St. Lucie Units 1 and 2  
Docket Nos. 50-335 and 50-389

Florida Power & Light/St. Lucie's Response To Request For Additional Information Regarding Overall Integrated Plan In Response To Order EA-12-051, "Reliable Spent Fuel Pool Instrumentation"

Response to Request for Additional Information Regarding Overall Integrated Plan in Response to Order EA-12-051

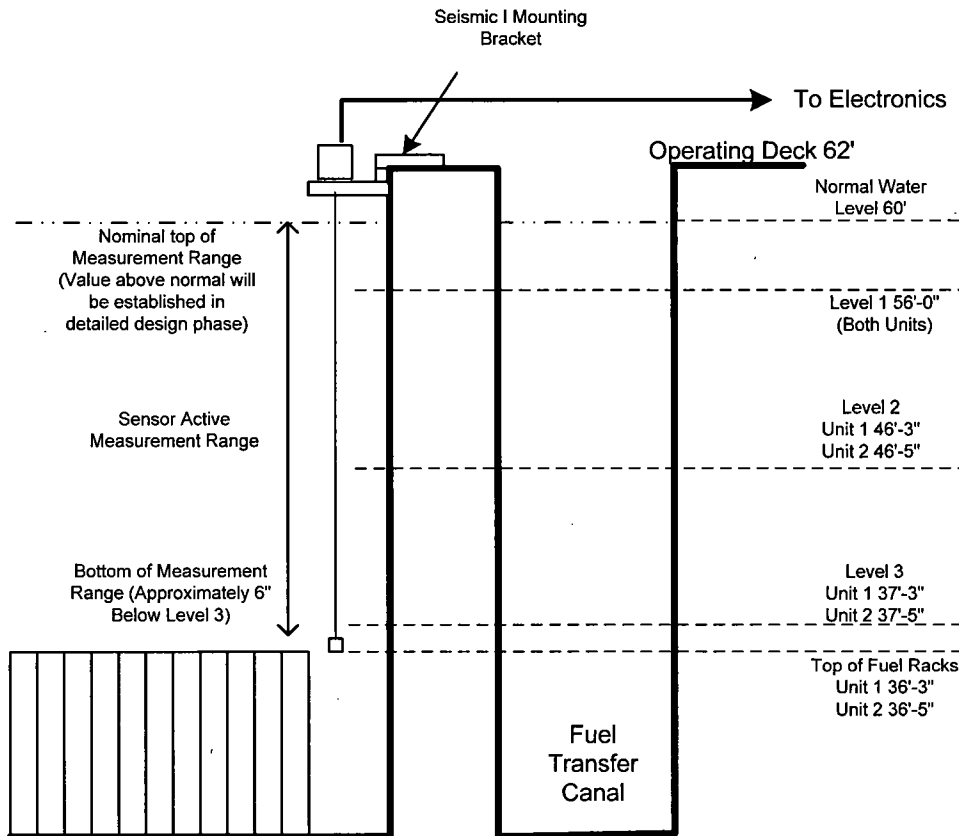
- a) For level 1, specify how the identified location represents the HIGHER of the two  
points described in the NEI 12-02 guidance for this level.*
- b) A clearly labeled sketch depicting the elevation view of the proposed typical  
mounting arrangement for the portions of instrument channel consisting of  
permanent measurement channel equipment (e.g., fixed level sensors and/or  
stilling wells, and mounting brackets). Indicate on this sketch the datum values*

*representing Level 1, Level 2, and Level 3 as well as the top of the fuel racks. Indicate on this sketch the portion of the level sensor measurement range that is sensitive to measurement of the fuel pool level, with respect to the Level 1, Level 2, and Level 3 datum points.*

The following sketch contains the information requested in RAI-1.b. Instrument uncertainty, which is to be determined, is not included in the elevation values for Levels 1 and 3.

Note that FPL is modifying the previously provided elevation for Level 3 based on subsequent industry and regulatory discussions that have occurred since submittal of the OIP.

NEI 12-02 describes Level 3 as the level where fuel remains covered and actions to implement make-up water addition should no longer be deferred. Level 3 corresponds nominally (i.e., +/- 1 foot) to the highest point of any fuel rack seated in the spent fuel pool. Level 3 is defined in this manner to provide the maximum range of information to operators, decision makers and emergency response personnel.

St. Lucie previously designated Level 3 as the actual top of the fuel storage racks. St. Lucie is now designating Level 3 as the water level greater than 1 foot above the top of the fuel storage racks plus the accuracy of the SFP level instrument channel, which is yet to be determined. Designation of this level as Level 3 is conservative; its selection assures that the fuel will remain covered, and at that point there would be no functional or operational reason to defer action to implement the addition of make-up water to the pool.

Accordingly, the previous Level 3 elevation of 36'-3" for St. Lucie Unit 1 is being revised to 37'-3" and 36'-5" for St. Lucie Unit 2 is being revised to 37'-5".
